CS Memorandum No. 1312

To: Distribution
From: Susan MacKenzie, Document Control Manager 
Date: December 18, 2012
Reference: Project No. M544.1, Contract No. CS-149
Task No. 1-8.02, Change Control
Subject: Configuration Management Board Meeting No. 103

SUBJECT: Configuration Management Board Meeting # 103– Rev. No. 0

Project No. M544.1, Contract No. CS-149
Program/Construction Management
Configuration Management Board (CMB) Meeting No. 103
November 28, 2012
3:00pm – 5:00pm
 Central Subway Project Office
 821 Howard St. 2nd Floor
 Main Conference Room

\Drawings\2-Civil\Joint Trench\Sheet Files CP01\M54421JT402_R1.dwg wseng Thu Aug 20, 2009 9:44 am JT-402
 \CentraSubway\ncsm544.1

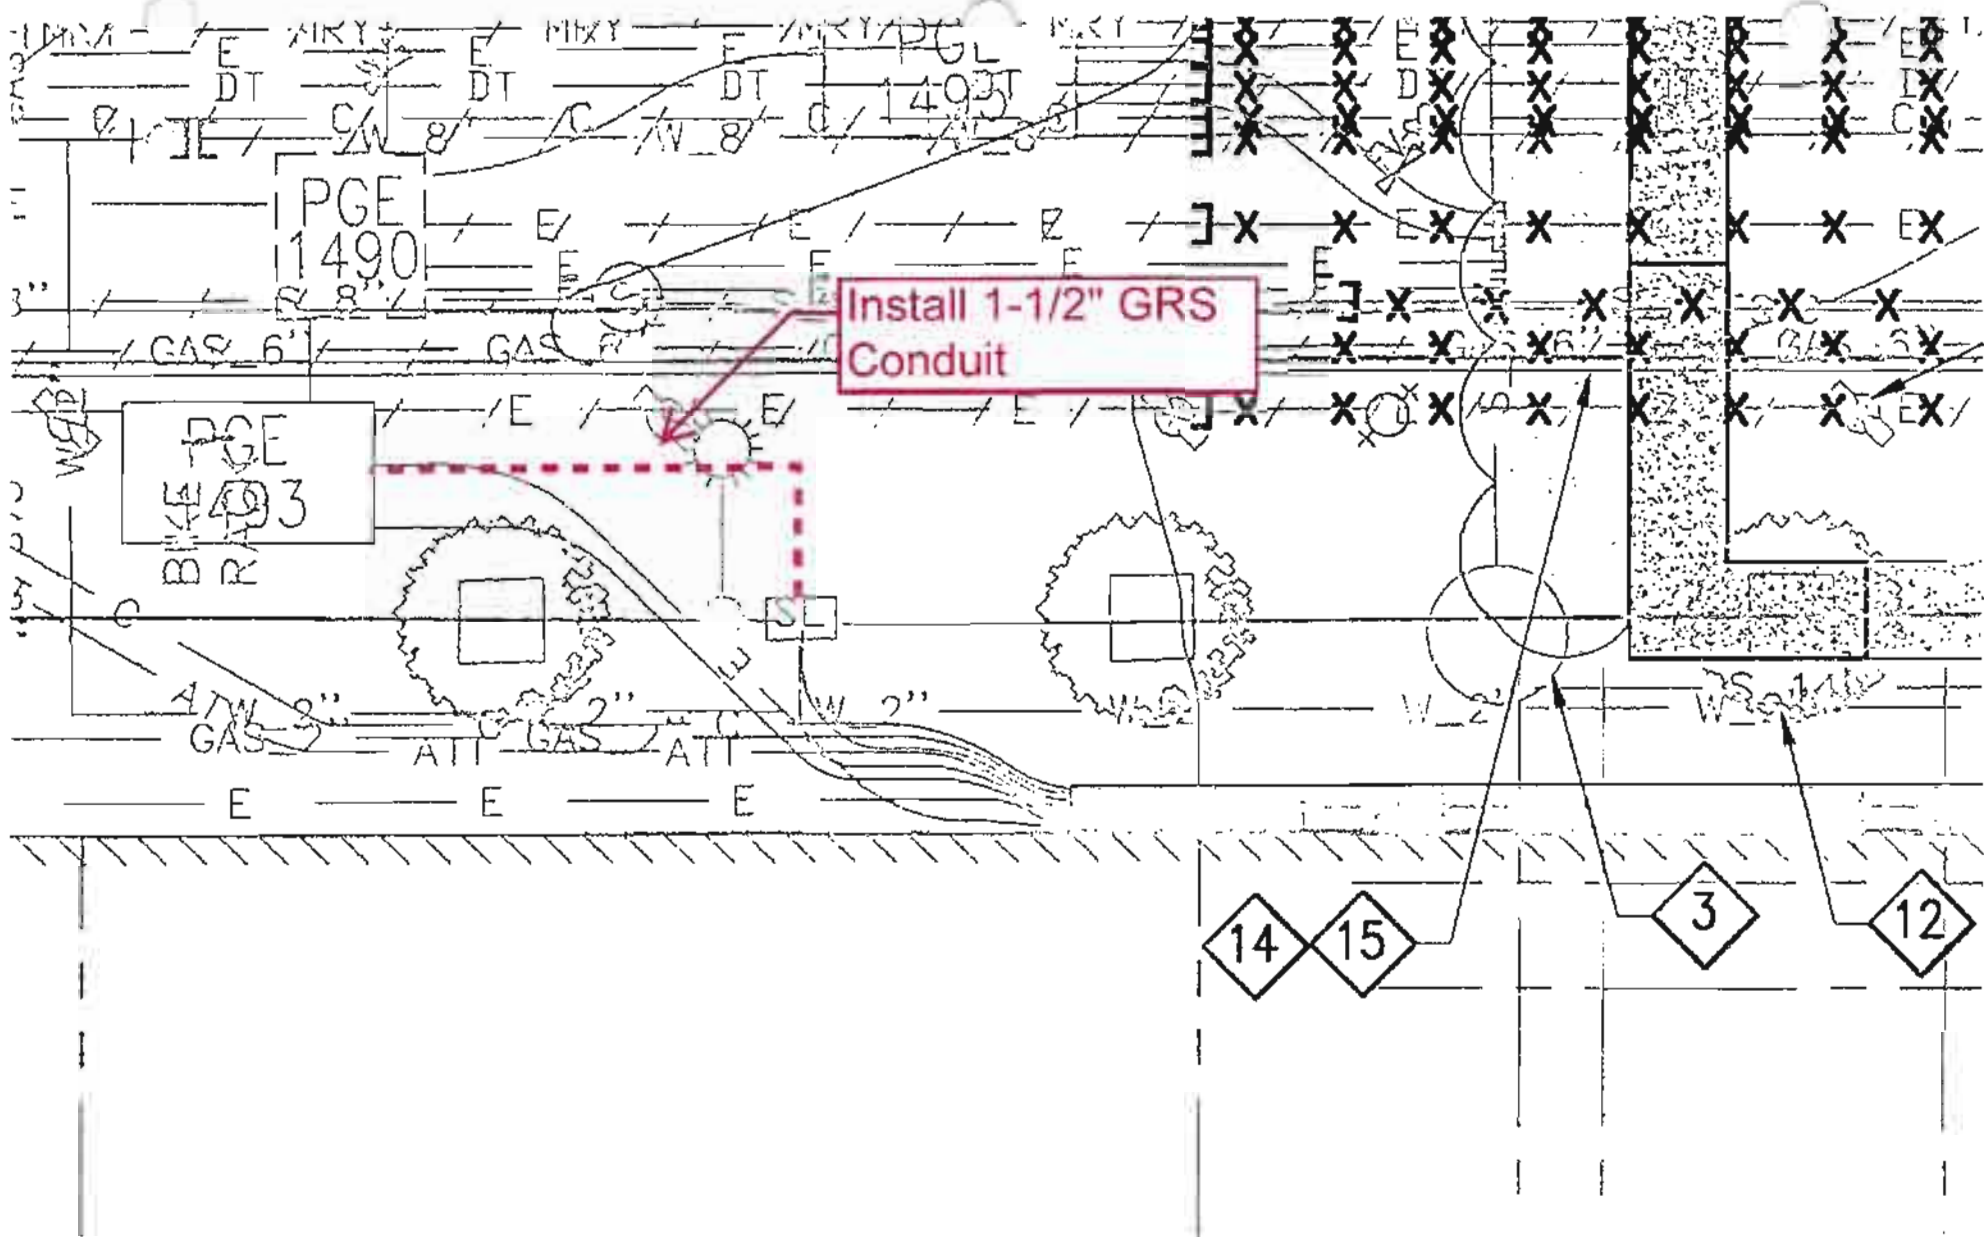
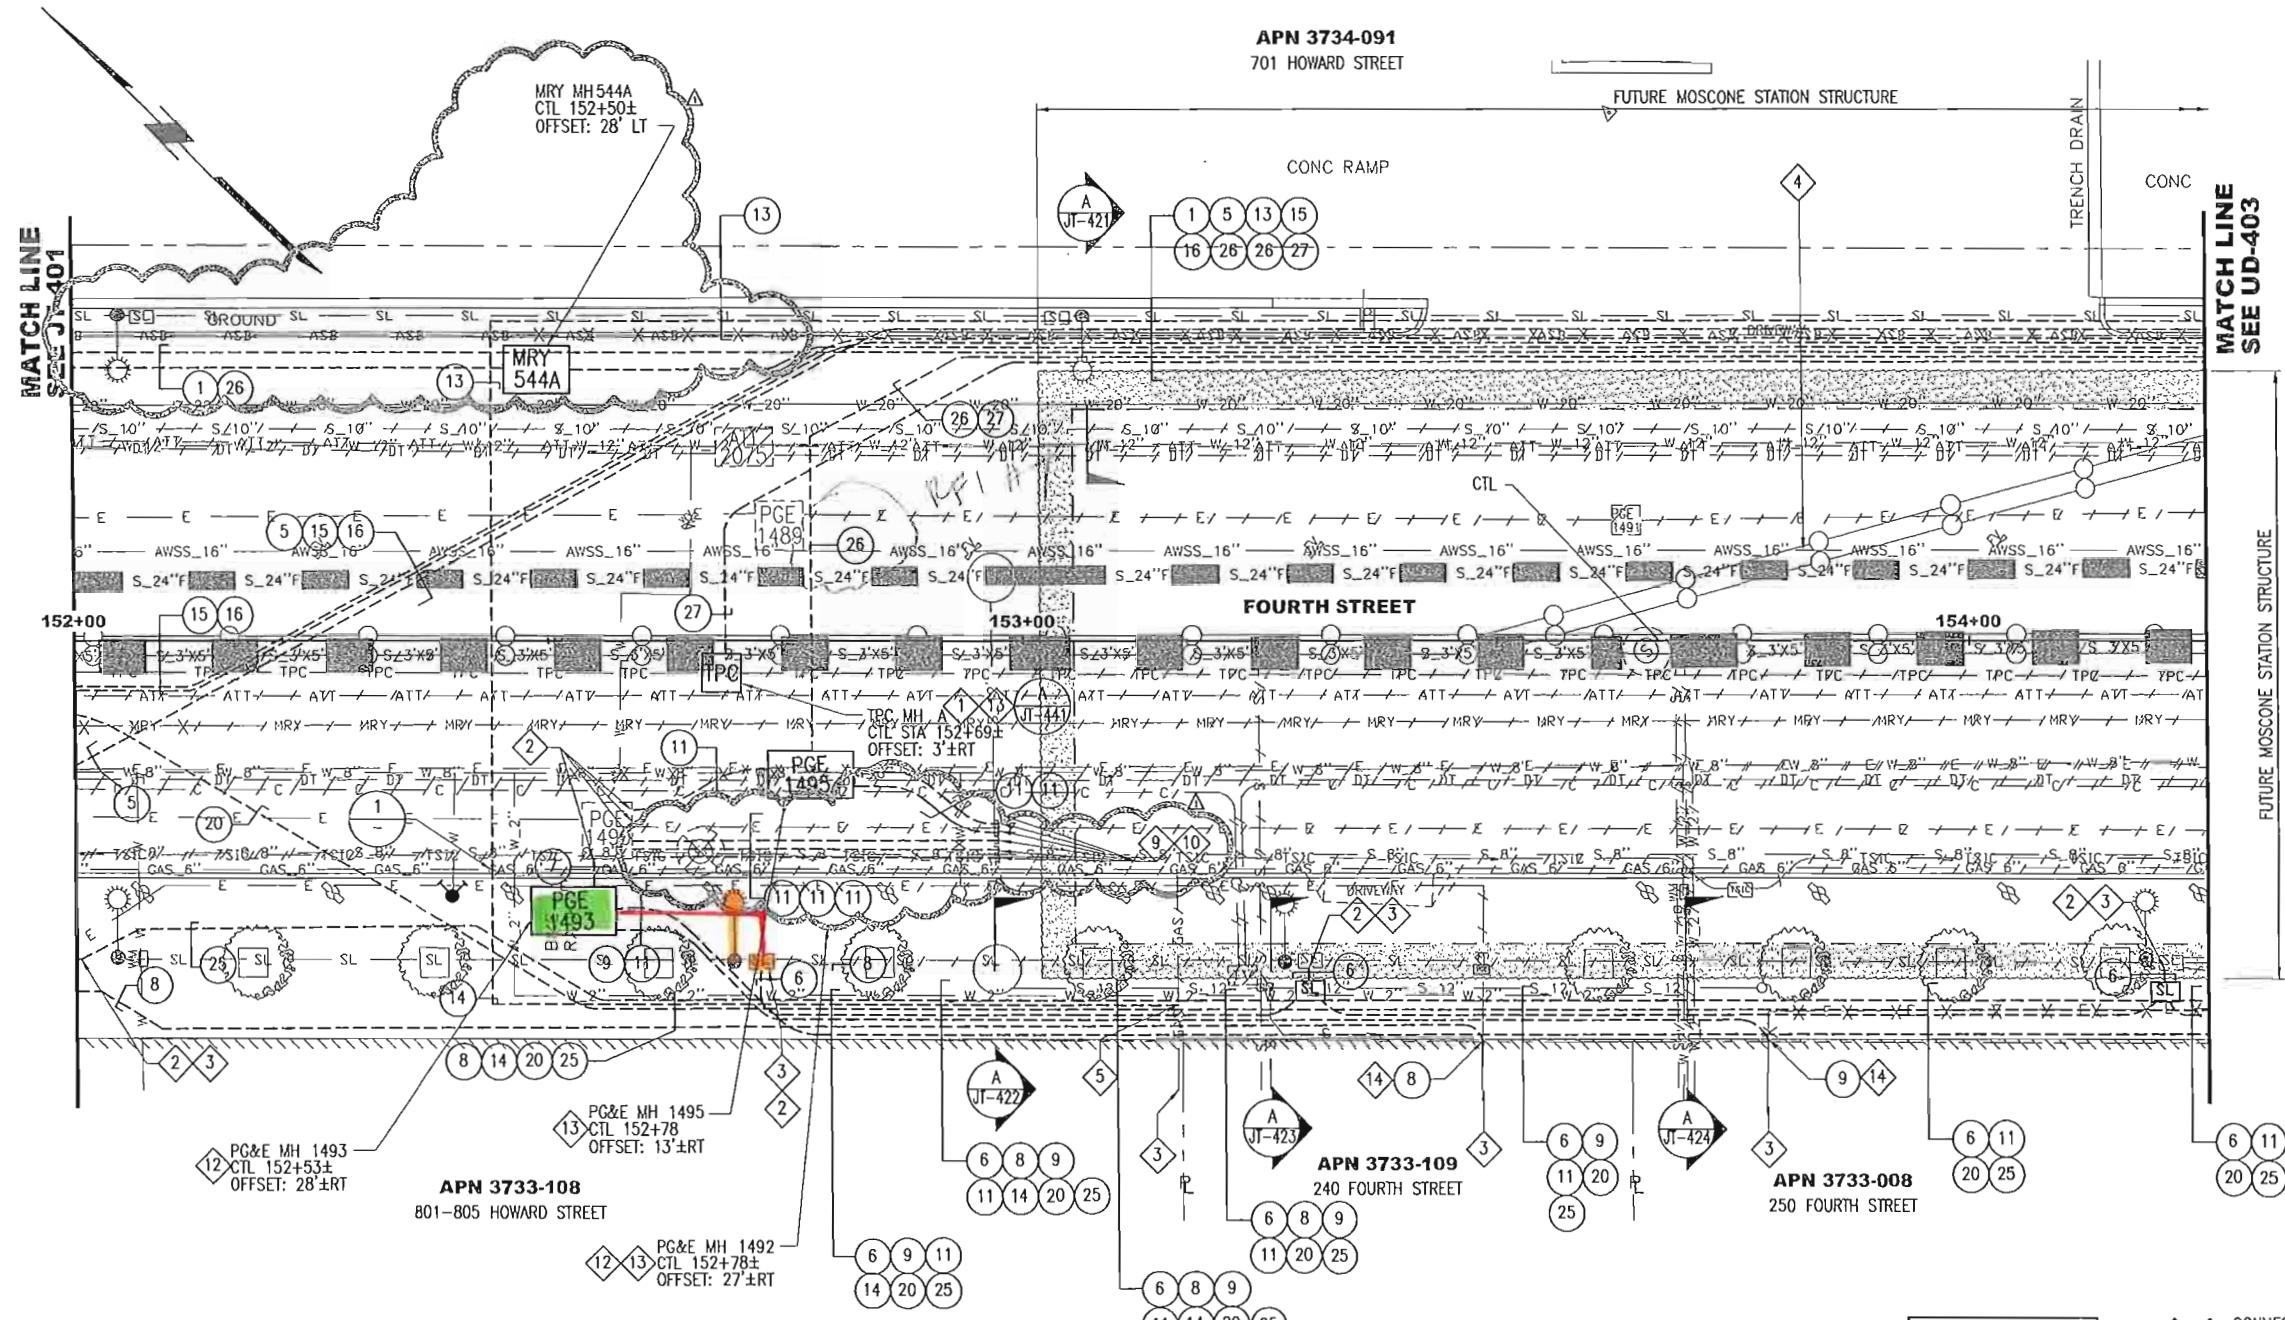
Recommendation: Accept justification of Merit for COR 013, for installing conduit for permanent power to an existing street light on Fourth Street near the north headwall at Moscone Station. The Contractor did not submit a request for time extension for this work.

Facts: When PG&E de-energized Vault #1494 to accommodate 1252 construction, an existing street light located on Fourth Street at the north-west side of the north headwall at Moscone Station (shown on Dwg. No's. UD-402 Rev.0 and UT-402 Rev.0), lost power. PG&E inspected Vault #1622 on Clementina St. and discovered that it is not available as a power source. A connection must be made to Vault #1493 for permanent street light power.

Justification: SFMTA requested that BIH install conduit to connect the street light to permanent power through PG&E Vault #1493. Approximately 20' of 1.5" diameter GRS conduit was required to be installed from PG&E Vault #1493 to the street light. Work required to provide permanent power to the existing street light was not shown in the Contract 1252 documents.

S:\6\003\m544.1\FinalDesign\Drawing-821\2-Civil\Utility Demolition\Sheet Files CP03\M54423UD502.dwg FBayani Wed Jan 26, 2011 2:34 pm UD-502

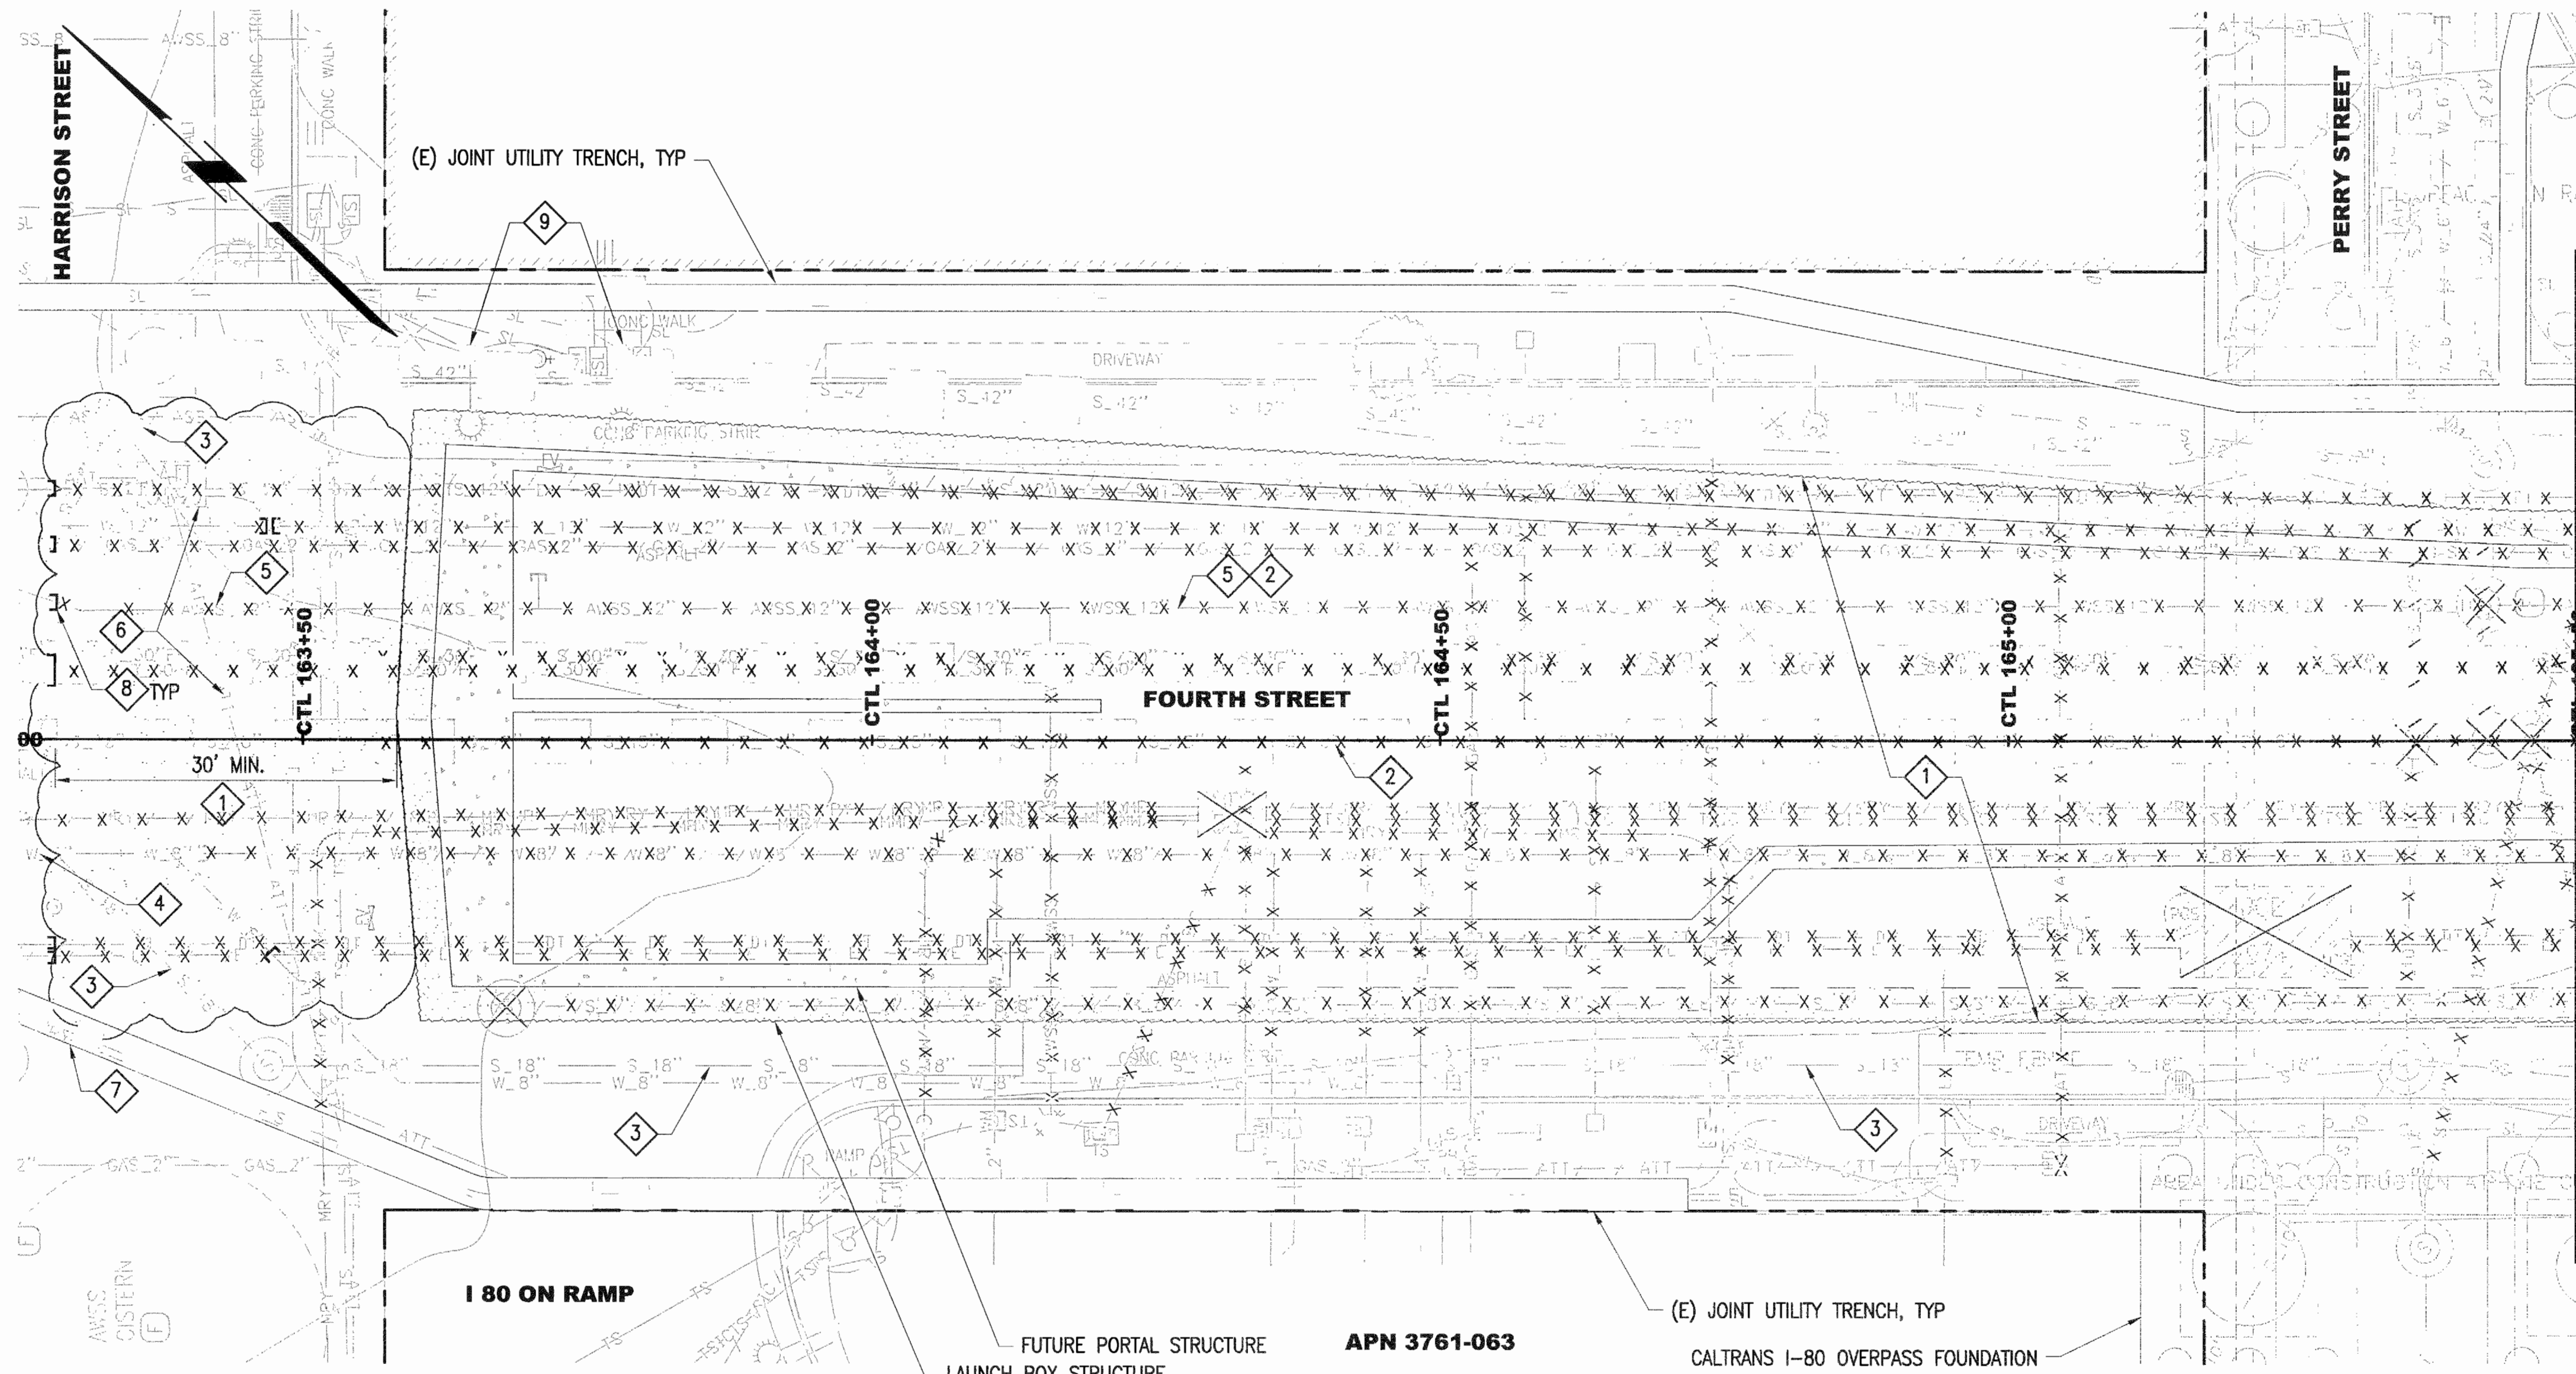
Recommendation: Accept justification of Merit for COR 015, for pre-excavation to remove concrete encased sewer line at the west slurry wall of the tunnel launch box. Time impact associated with this COR has not yet been determined.

Rationale for COR: The sewer line encased in concrete was a differing site condition. Additional costs were incurred to remove the concrete and place additional slurry (bentonite and water) to fill the resulting over-excavated wall width due to the concrete encasement removal.

Justification: The contract documents show that the concrete encased sewer pipe was at a depth shallower than was found at the Site. For the condition shown in the contract documents, the VCP sewer line could have been broken and removed along with the soil excavation during the Contractor's guide wall construction. Additional equipment and labor were required to remove the concrete and to fill the resulting over-excavated wall width with additional slurry. The work was required to be completed before the Contractor's slurry wall production could continue.
